# Watertown

Main Street - Route 63 – Road Safety Audit

June 13, 2018

Figure 11. Steep Slope and Stone Wall

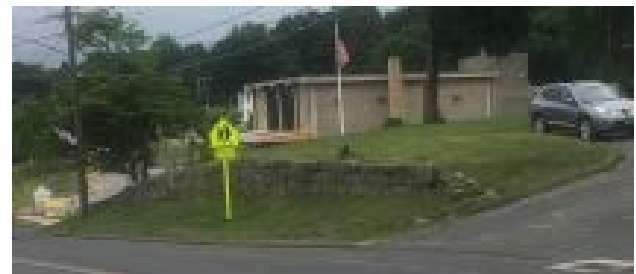
- One section of missing sidewalk on the west side is adjacent to a steep slope and stone wall. (Figure 11) Adding sidewalk at this location will be difficult due to the location of the wall and the steep slope.

Figure 26. Sidewalk gap on west side, poles in sidewalk on east side

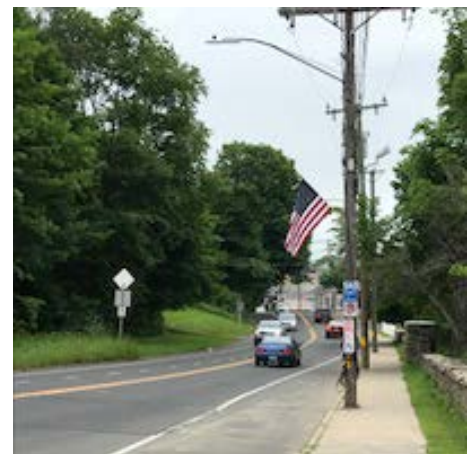
- Several utility poles are currently in the sidewalk (Figure 26).
- Sidewalk condition is degrading in some locations (Figure 27).
- Some of the wide sections of sidewalk could be good locations for grass strips and/or plantings.

- Northbound traffic was noted as being faster and more of a hazard.
- Sidewalk on the east side of the street near French Street could be improved by widening and upgrading sidewalk based on condition and adjusting to eliminate conflicts between sidewalk and utility poles.

Figure 33. Short Term Recommendations

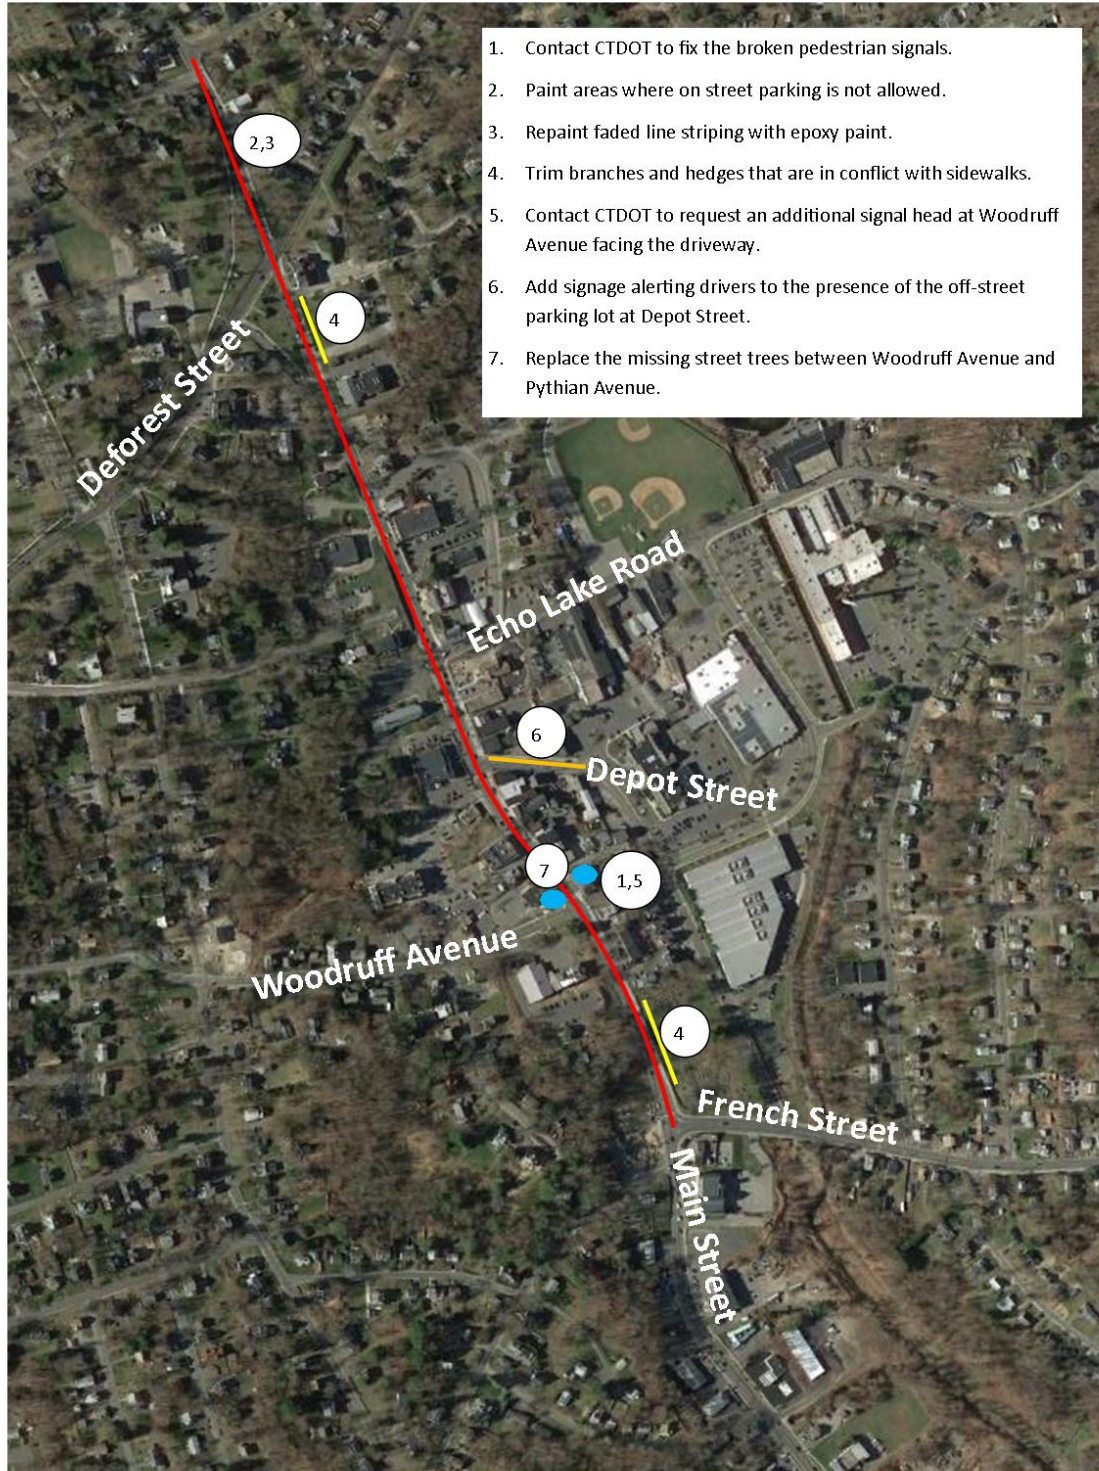
1. Contact CTDOT to fix the broken pedestrian signals.
2. Paint areas where on street parking is not allowed by means of cross hatching on pavement and yellow curb paint (Figure 30, Figure 31). Consider adding painted bump outs at mid-block crossings and intersection corners.
3. Repaint faded line striping with epoxy paint.
4. Trim branches and hedges that are in conflict with sidewalks.

Figure 42. Long Term Recommendations

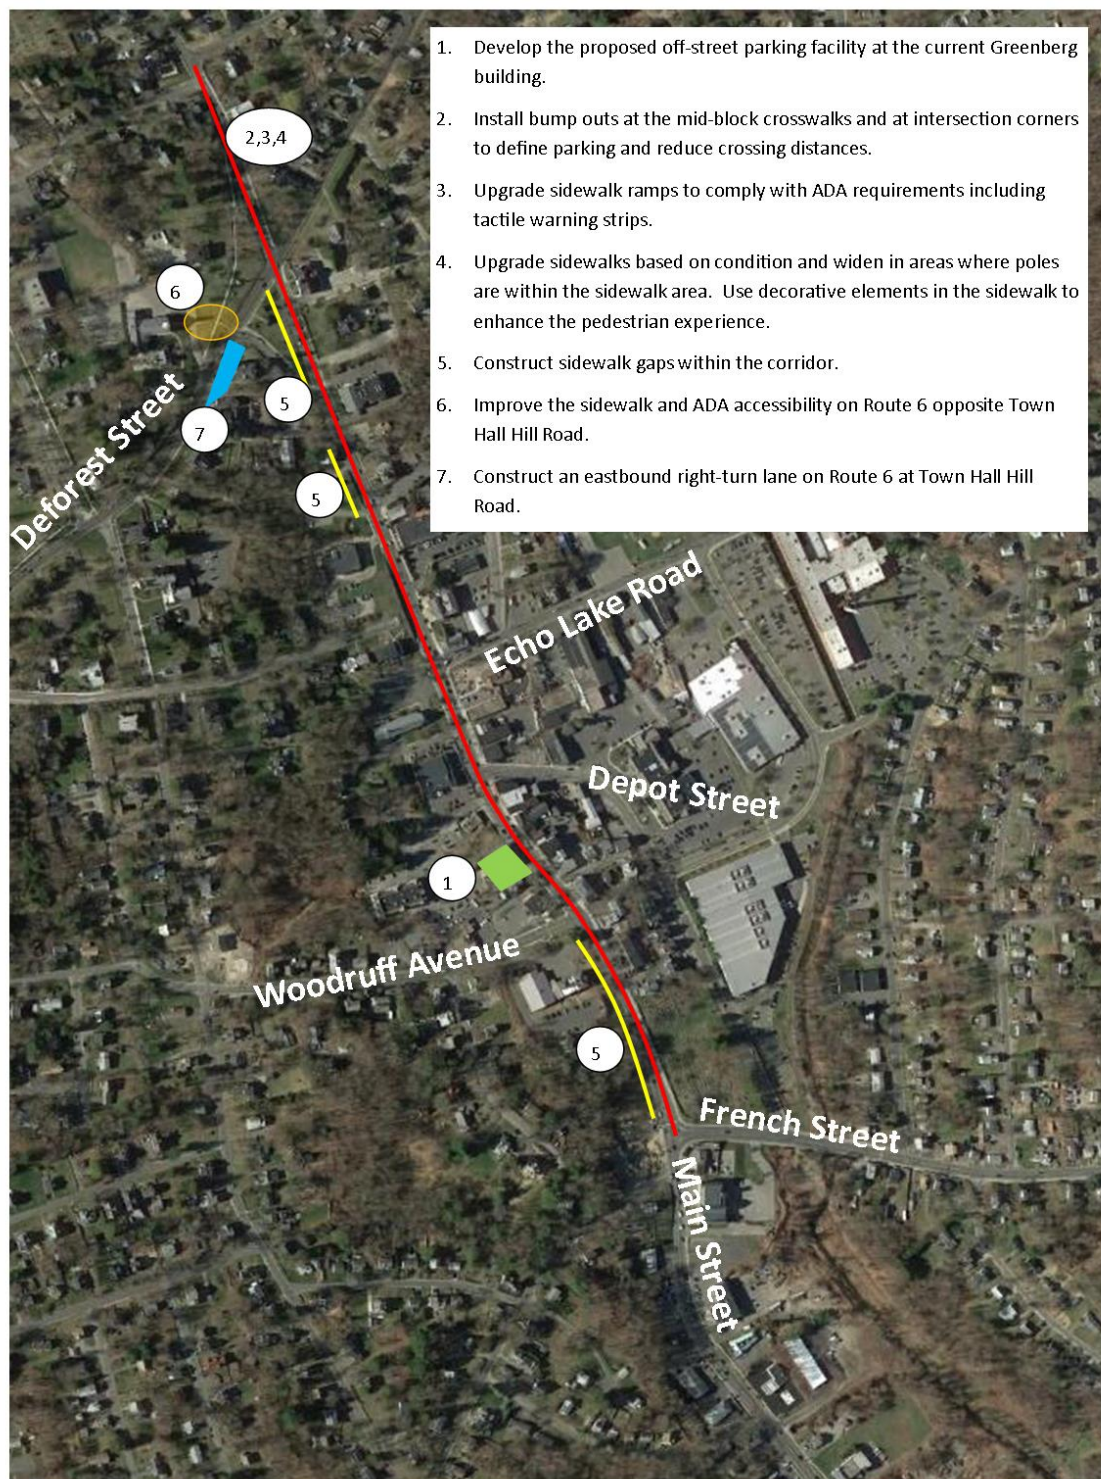
1. Develop the proposed off-street parking facility at the current Greenberg building.
2. Install bump outs at the mid-block crosswalks and at intersection corners to define parking and reduce crossing distances (Figure 39).

3. Upgrade sidewalk ramps to comply with ADA requirements including tactile warning strips (Figure 40).
4. Upgrade the sidewalks based on condition and widen in areas where poles are within the sidewalk area. Use decorative elements in the sidewalk to enhance the pedestrian experience.
